PRODUCT CHANGE NOTIFICATION

PCN-DC-WM9R-14

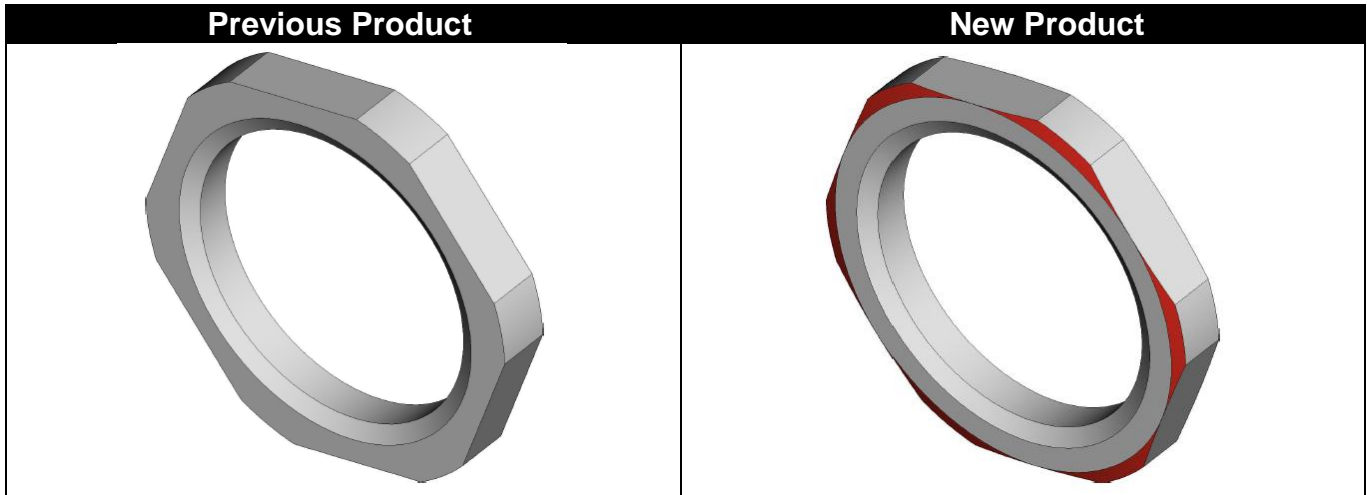
Due to the optimization of the production process, the nut will now have a chamfer on both sides. A new advantage is that the nut ,with the addition of the chamfer, will now avoid scratching painted housings.
